SUBJECT: Addresses concerns summarized in NRC 850206 ltr re detailed control room design review program, per Suppl 1 to NUREG-0737.

March 5, 1985  
(NMP2L 0361)

Re: Nine Mile Point Unit 2  
Docket No. 50-410

**FIGURE 1 - 1**  
**ACTIVITY SCHEDULE**  
**DETAILED CONTROL ROOM DESIGN REVIEW**  
**NIAGARA MOHAWK POWER CORPORATION**  
**NINE MILE POINT - UNIT 2**

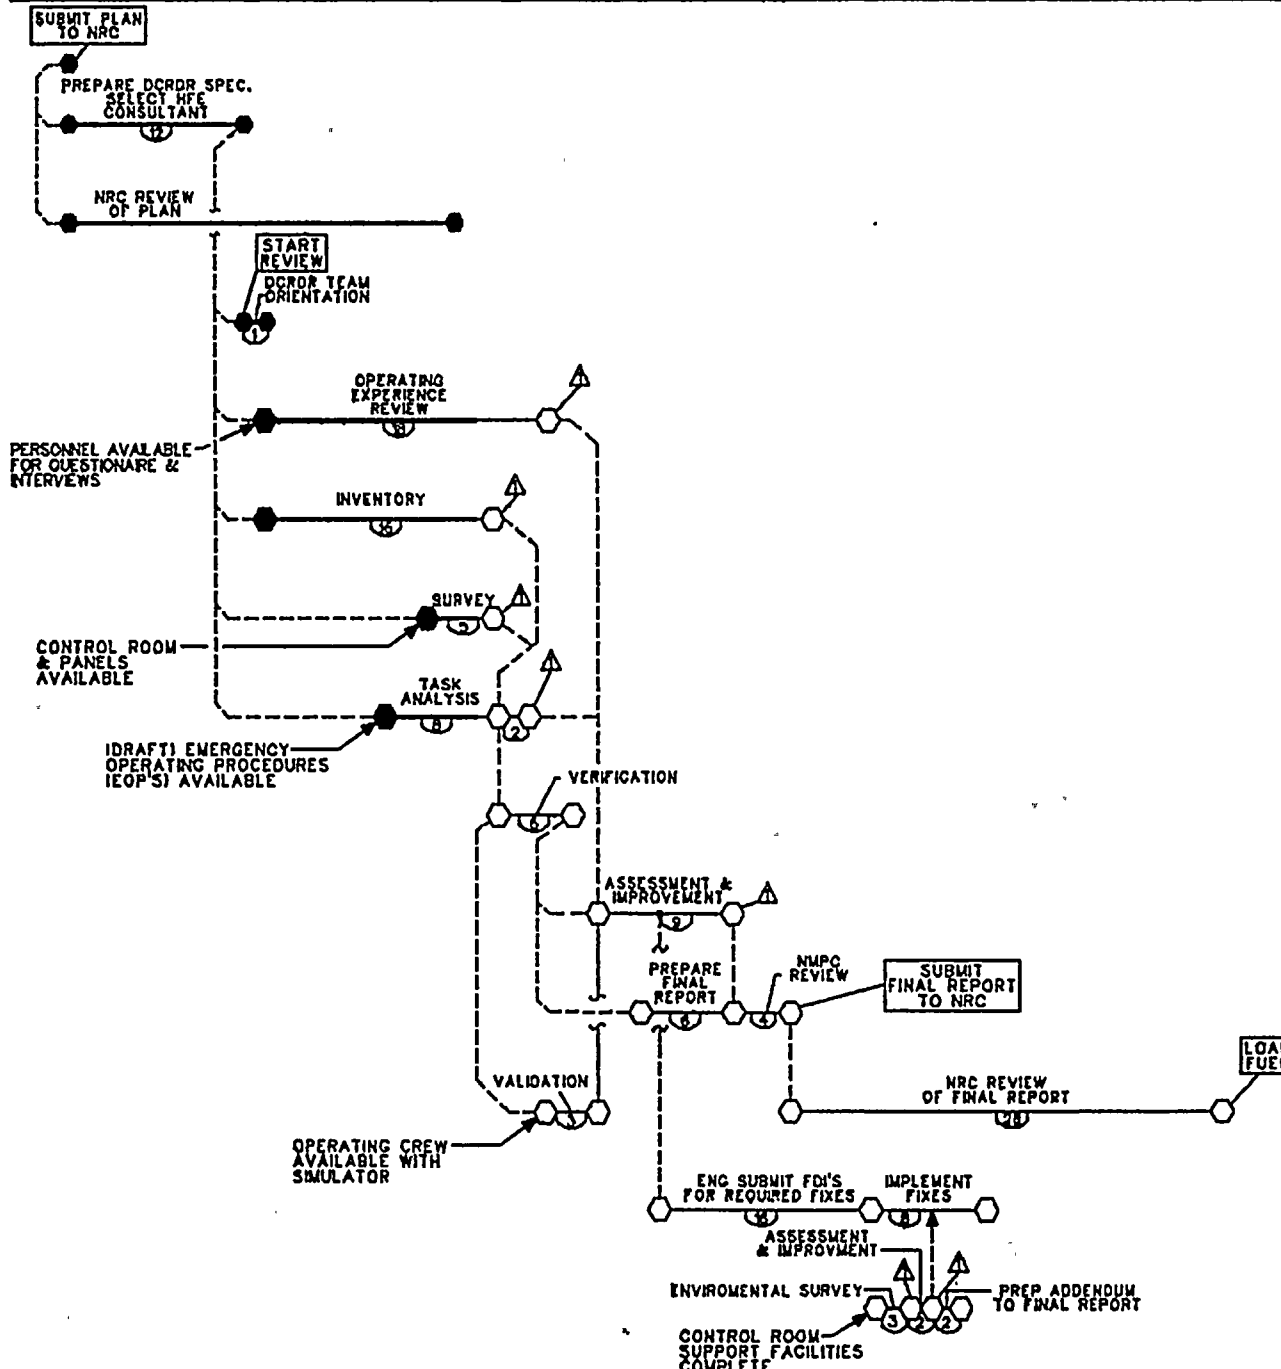
Compression of the DCRDR schedule into a seven month period is an ambitious undertaking.

The revised schedule (Attachment A) addresses this concern. Included in this new schedule is time for the NRC audit and the design verification in the assessment phase.
